**CURATIVE AMMENDMENT FOR APPLICATION FOR
LICENSE (302-AM)**

WVOZ-AM AGUADILLA, PUERTO RICO

BL-20180911ADH (CP:BP-20170327AAF)

Changes made to EE -Proof of Performance:

FIGURE 4 (SHEET 2 OF 17) RADIO STATION WVOZ-AM AGUADILLA, P.R.

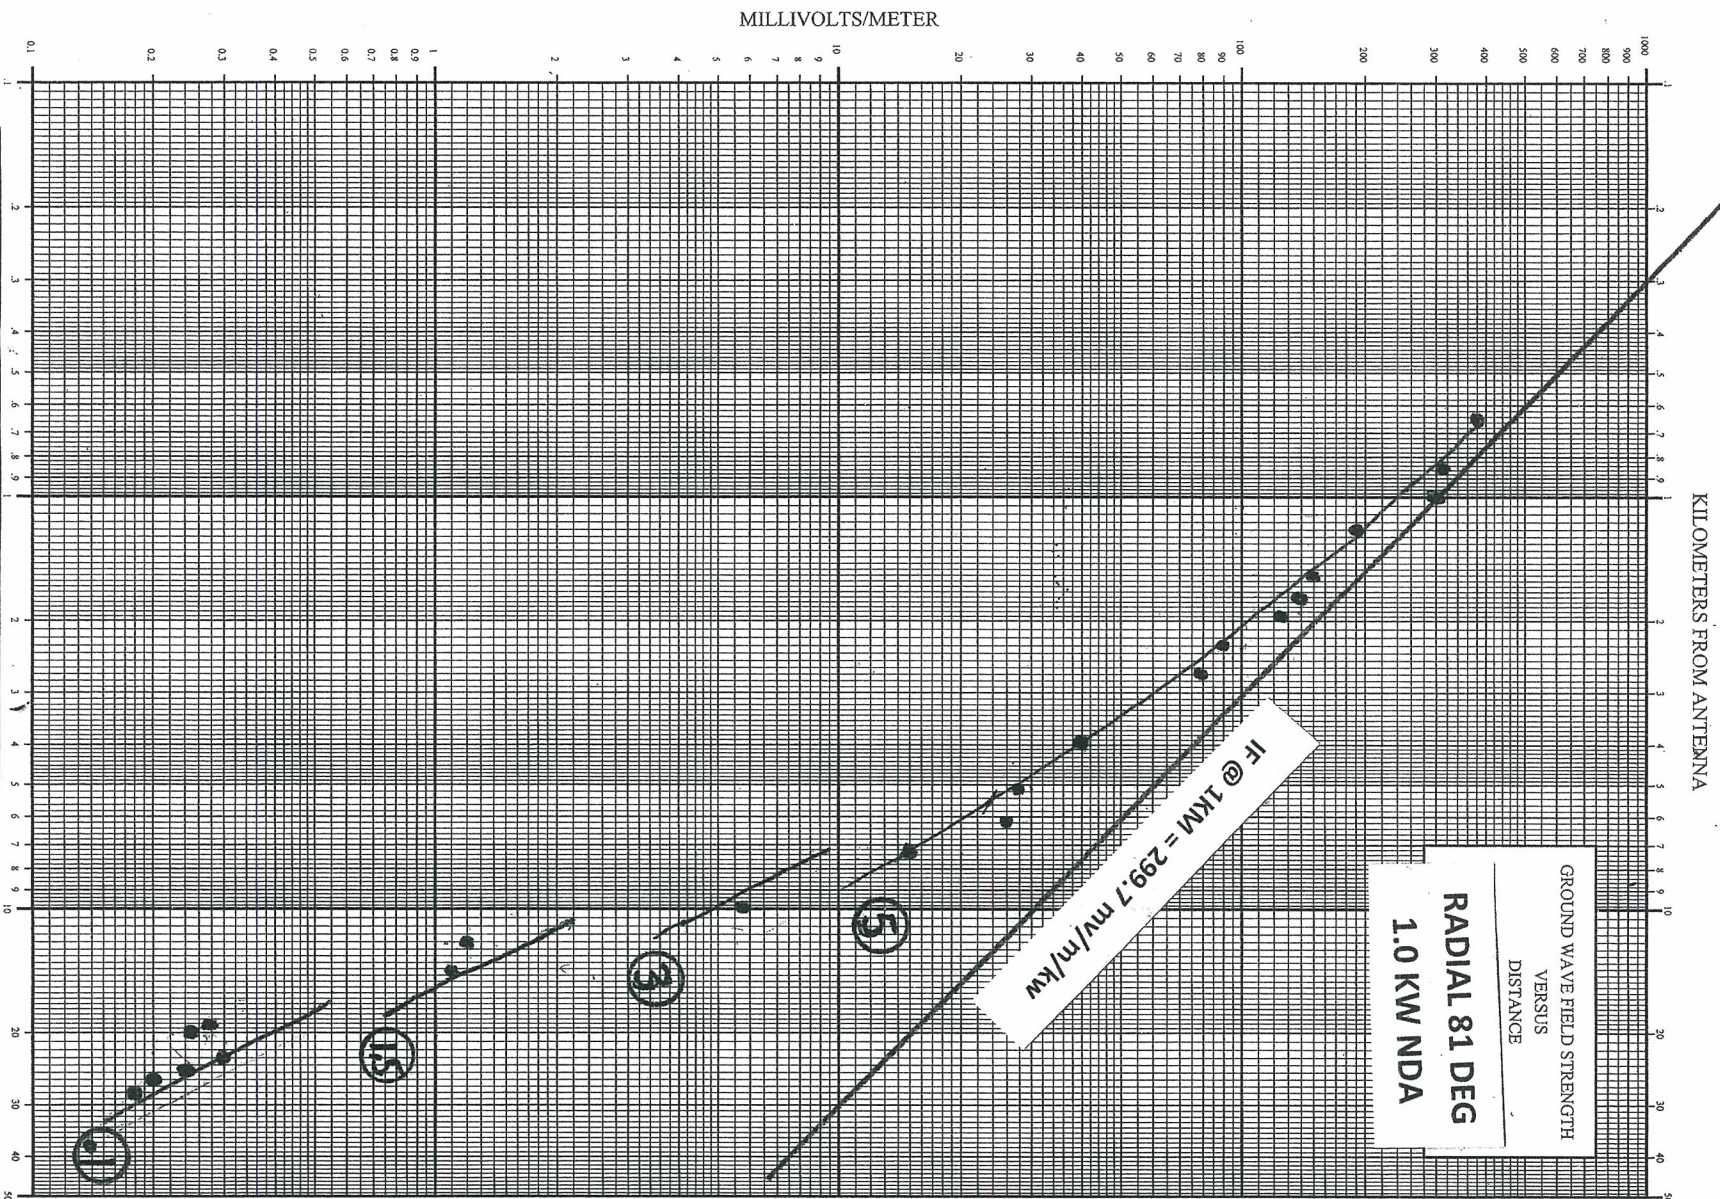
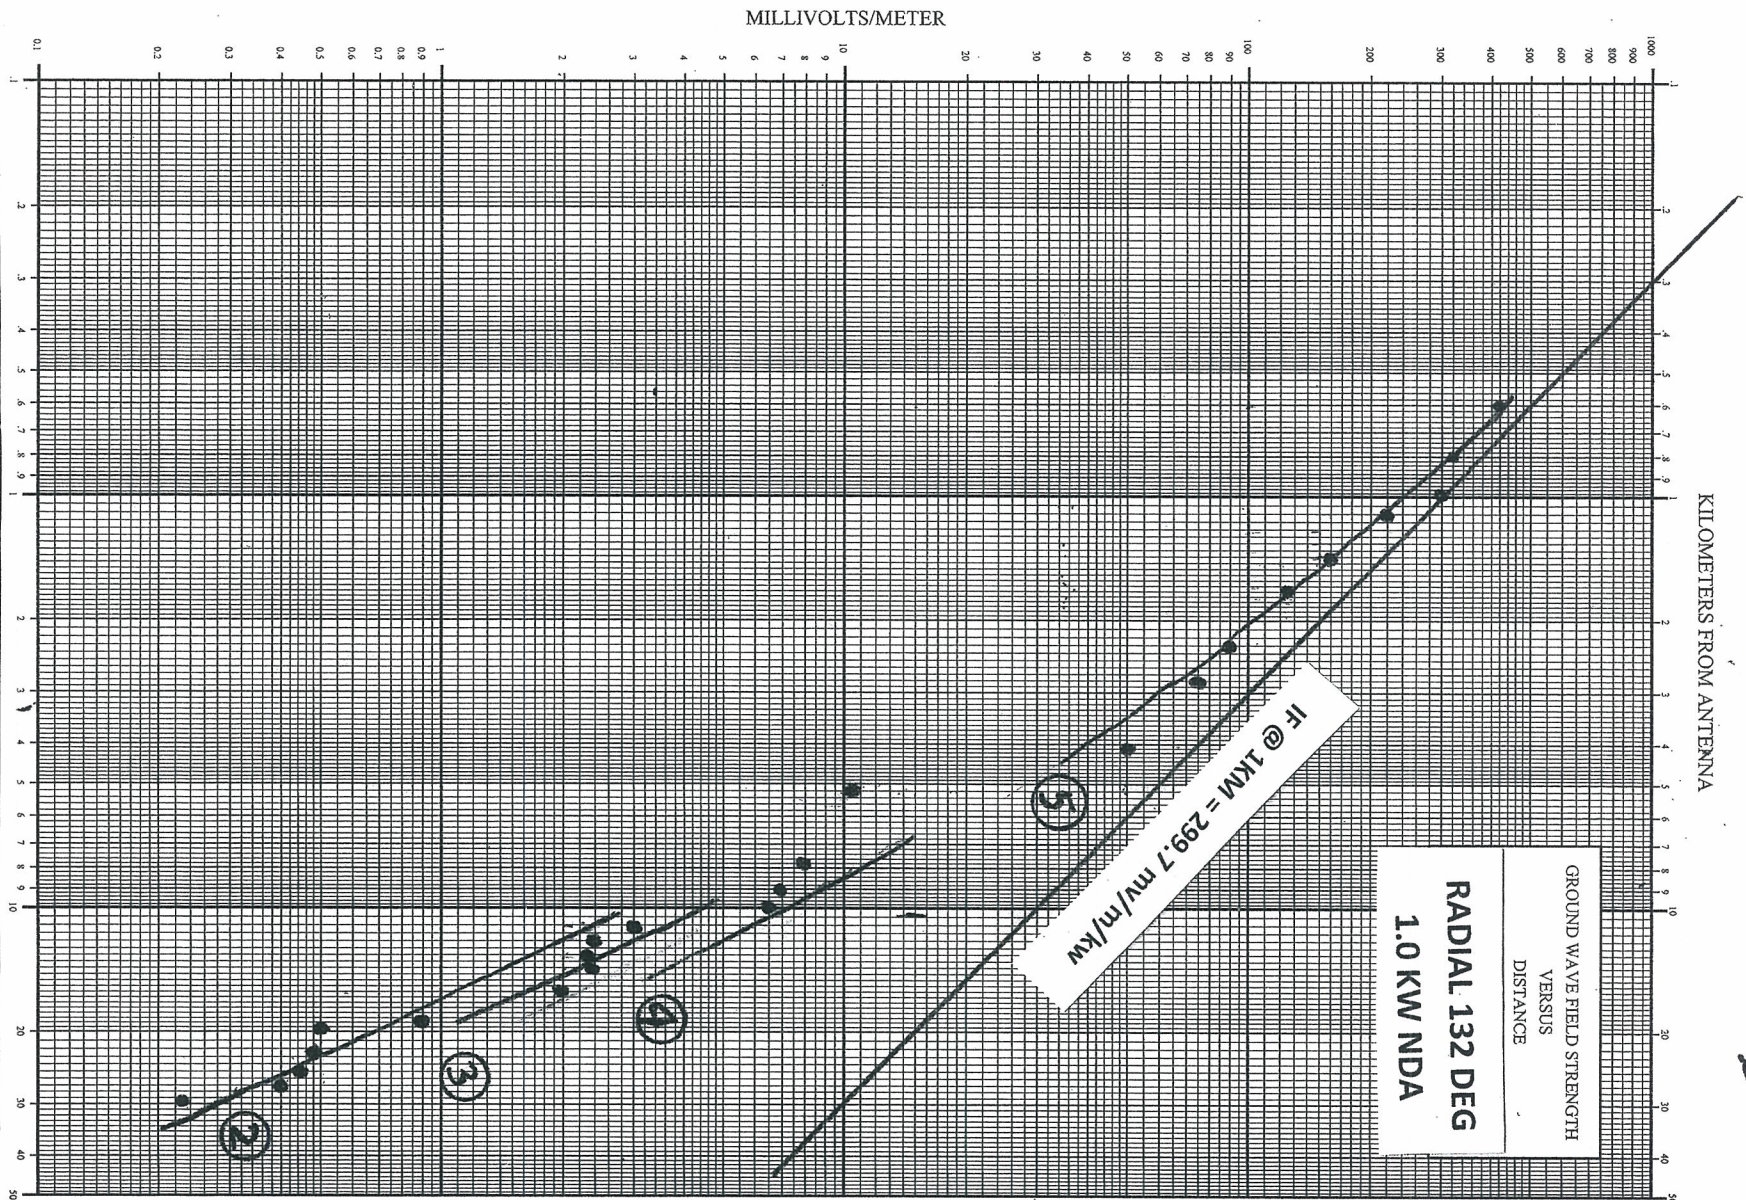
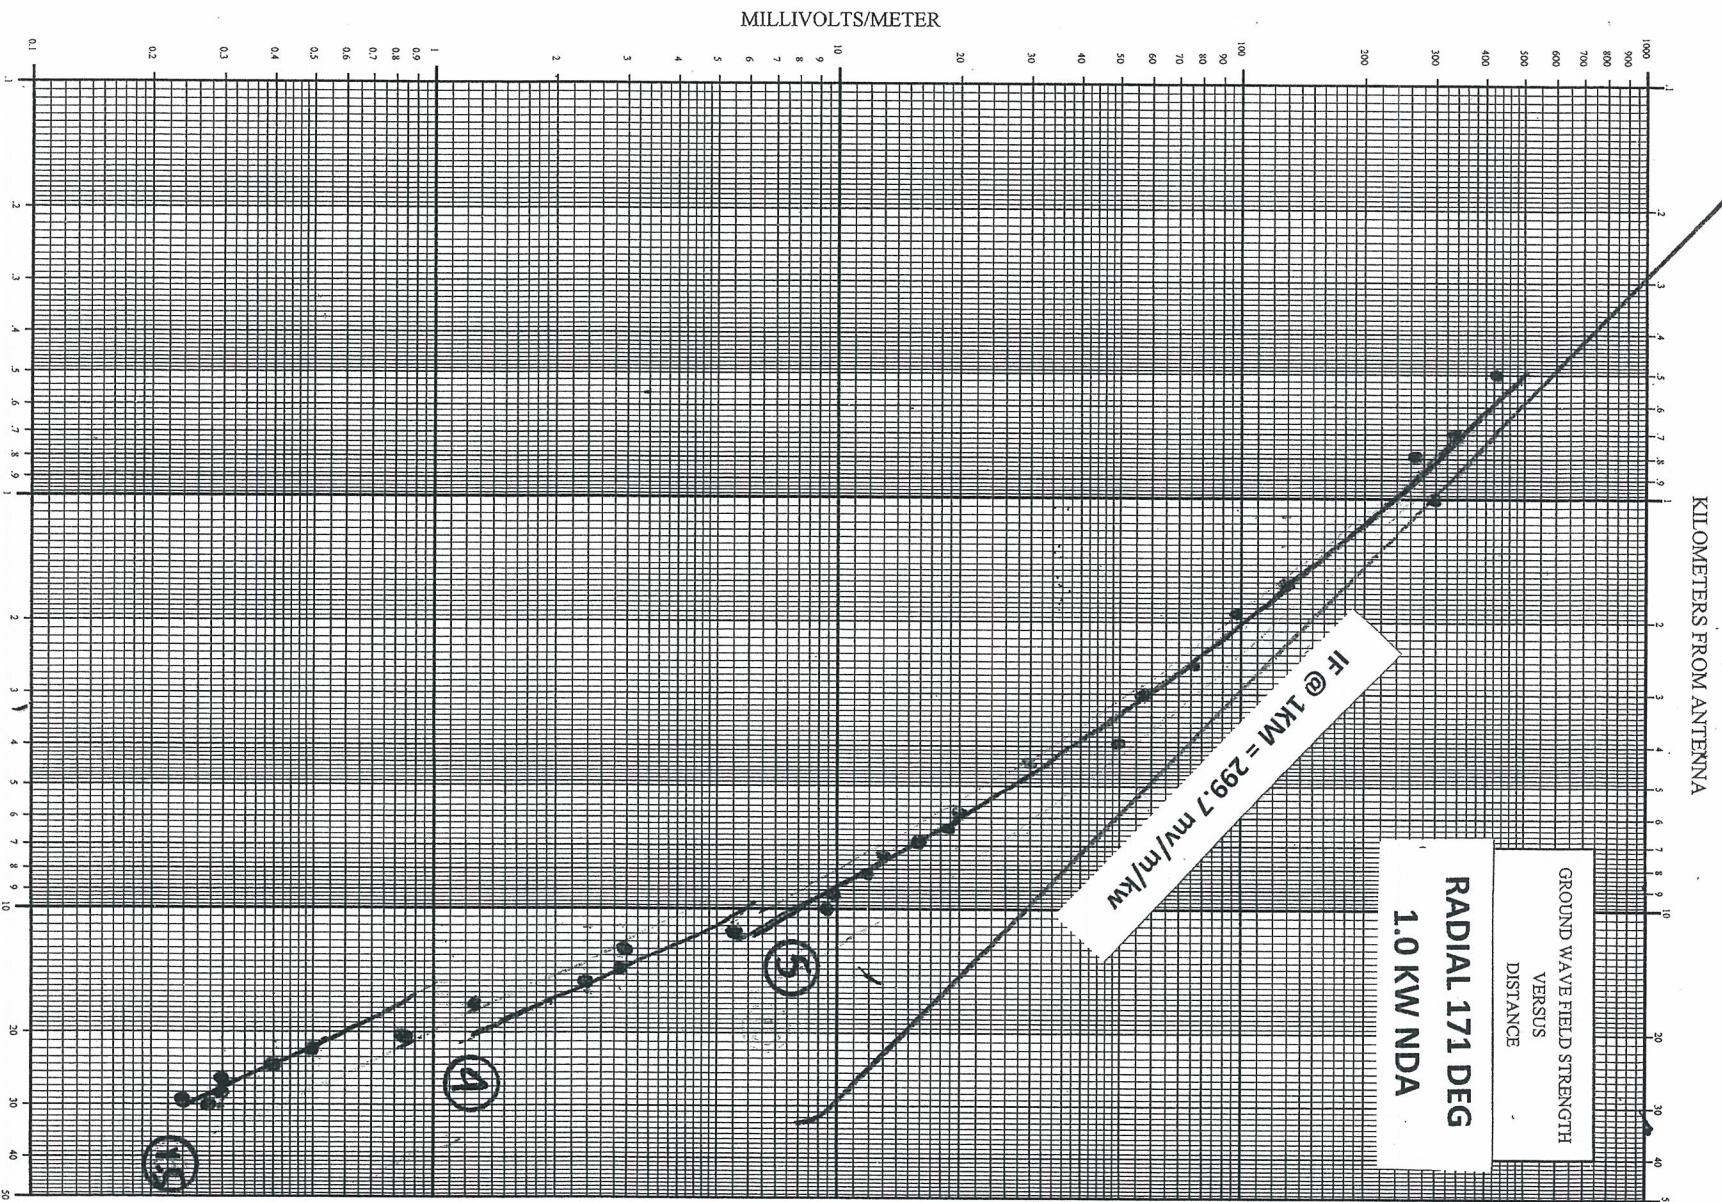
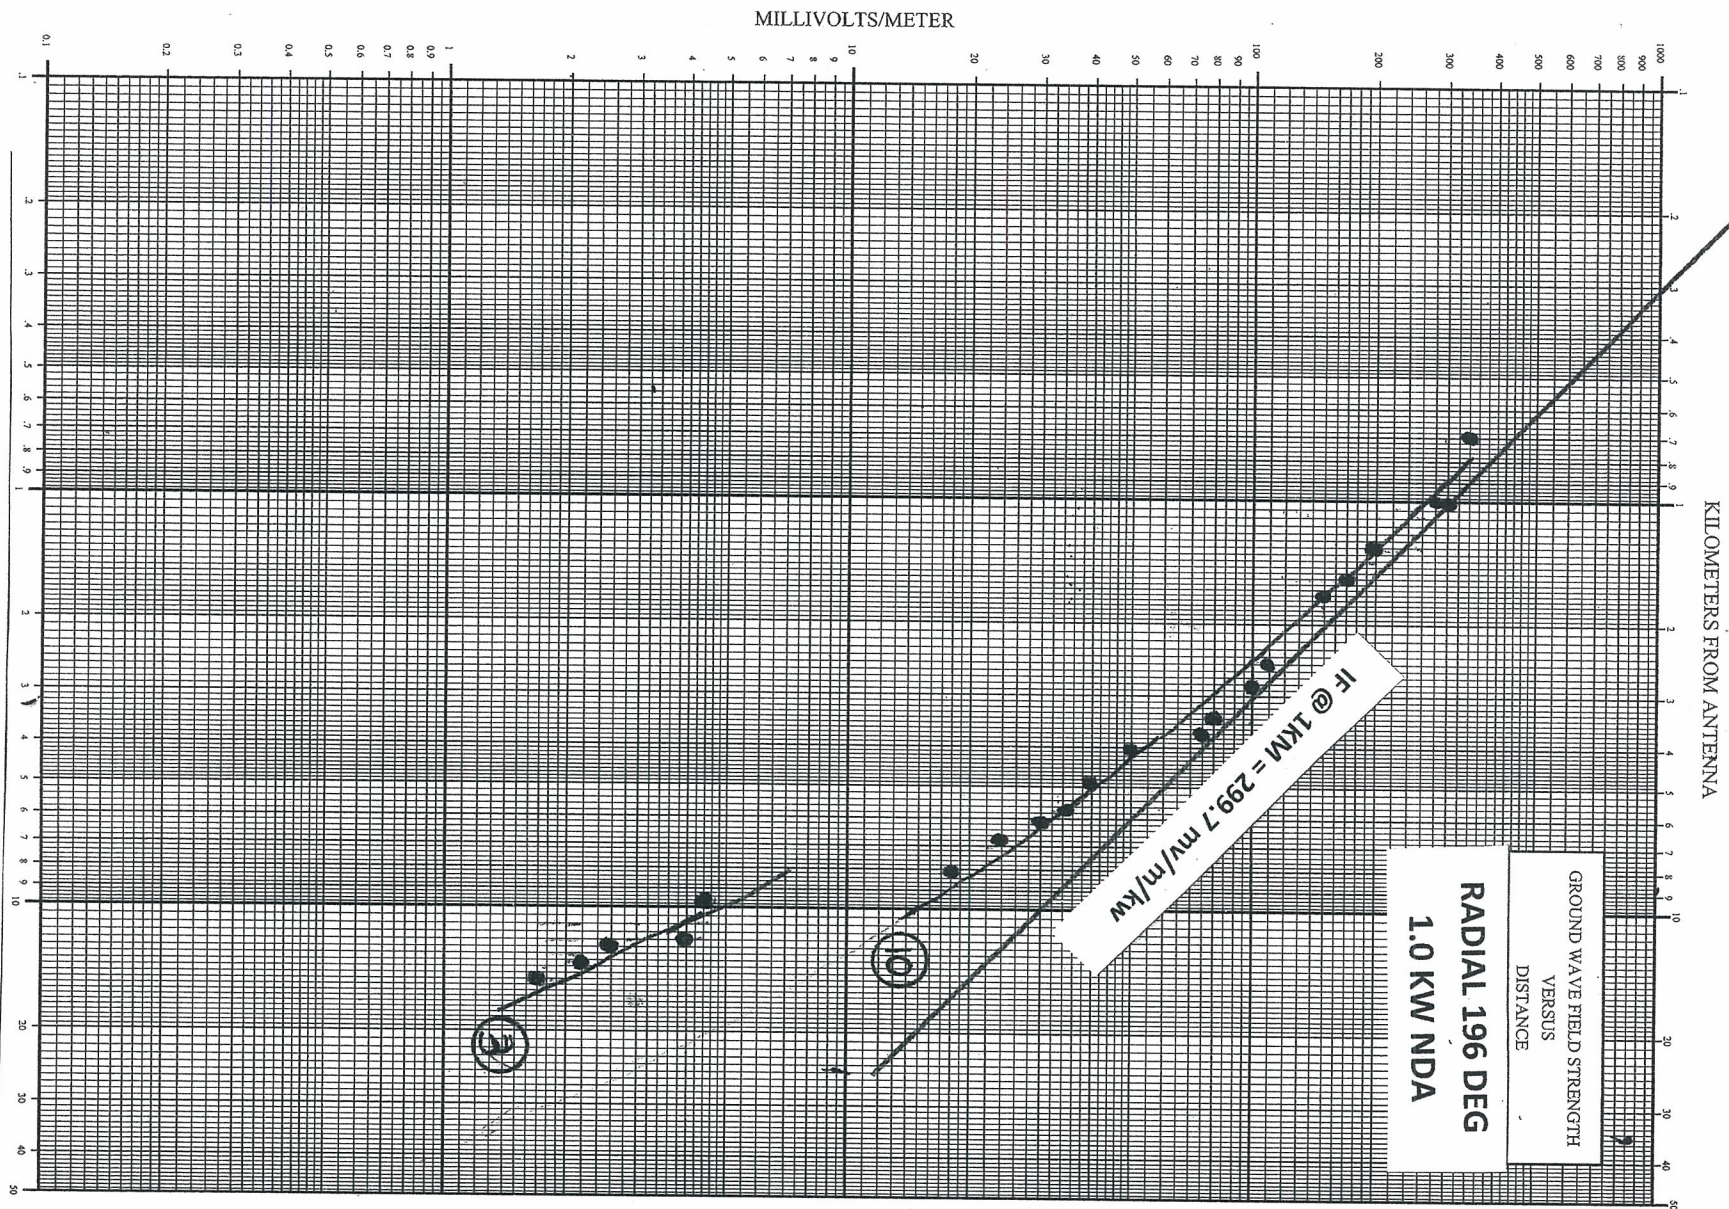
#1: By mistake, the secretary included as Figure 4 the incorrect set of graphs. The graphs that were included were an analysis tool and not the final graphs. The graphs incorrectly sent were used during the analysis process to figure out what the value for the points measured should most likely be after figuring out the attenuation curves by the best-fit method. That information was used to measure again most of the points that didn't fit on the conductivity curves selected for each radial to ensure the measurements originally taken were correct and that no error was made finding the correct point location and/or when taking the measurements.

The correct set of graphs is included for non-directional and directional. As you will see the conductivity curves chosen by the best-fit method are basically the same as the ones incorrectly sent. Although the email containing the PDF to the FCC was sent on Sept. 6/2018 and that same day the FCC emails back to us with the deficiencies, the paper filed copy was exactly the same as the one sent by email, since a curative amendment was immediately required by the FCC.

By this means, it is respectfully requested that the correct set of graphs along with the family of curves used to analyze them be made part of this curative amendment. (Please substitute the new set of graphs for each radial and insert Fig. 1 (Sheet 5A of 12: Family of curves for 1520-1600 downloaded from FCC page).
